# PLAN REVIEW CENTER REPORT

**Planning Review**  
**The Bond fka The District**  
JSP 18-10

Revised Preliminary Site Plan

#### REVISED OPEN SPACE PLAN

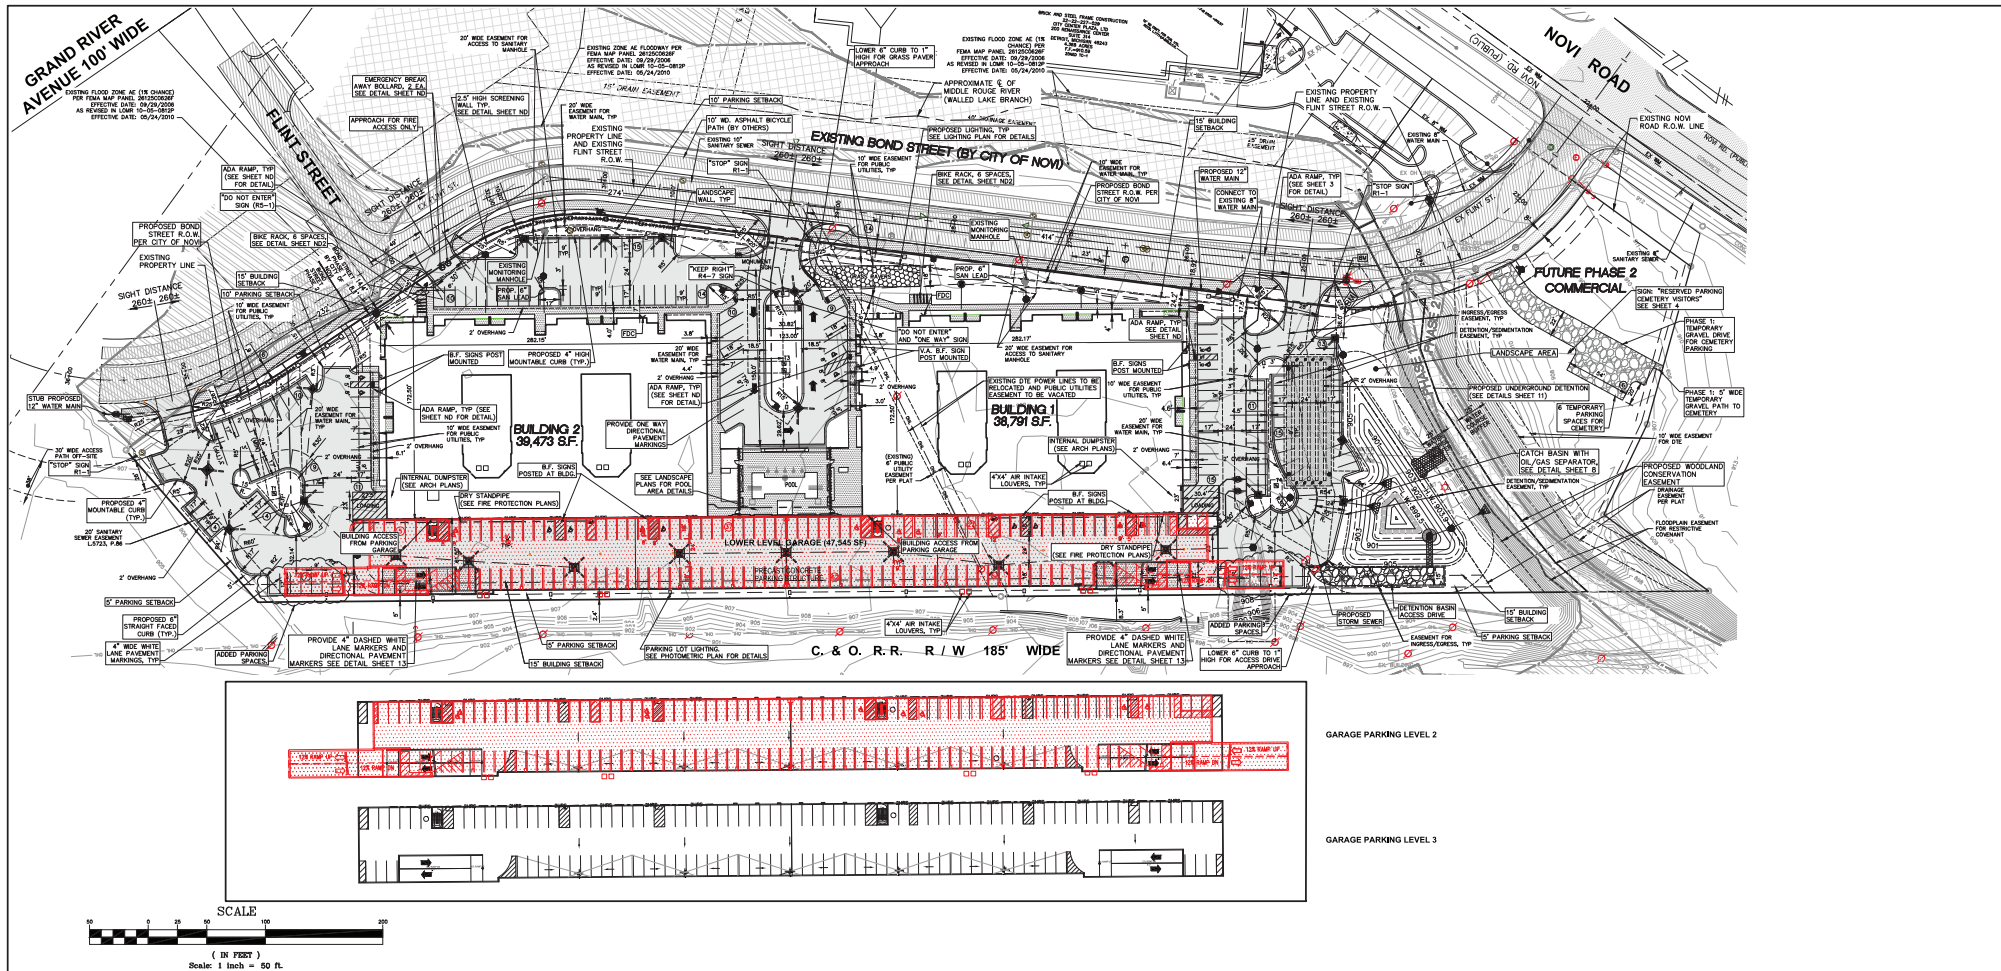
1. REVISED PARKING DECK TO 3 - LEVELS (ORIGINAL PARKING DECK SHOWN IN RED)

2. ADDED 14 SURFACE PARKING SPACES

BLDG TYPE - I - 1ST FLOOR PLAN

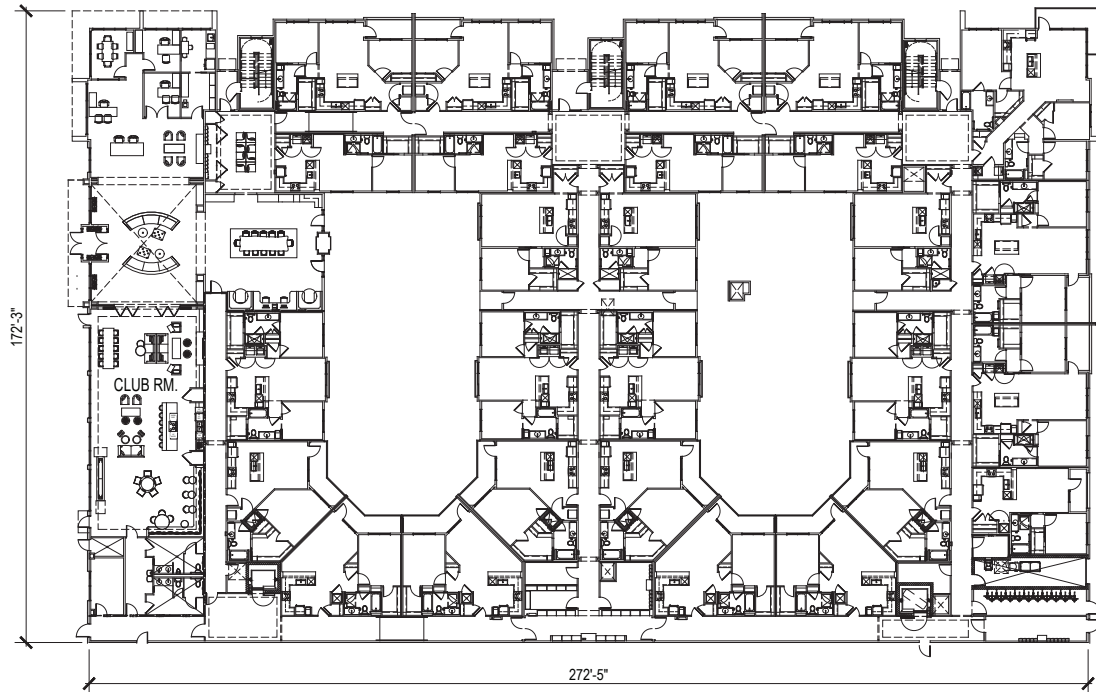
| Efficiency-400    | 1 | Not proposed |  | <b>Unit tabulation on Sheet A410 shows “Bed Count” rather than “Room Count” as specified by ordinance</b> |
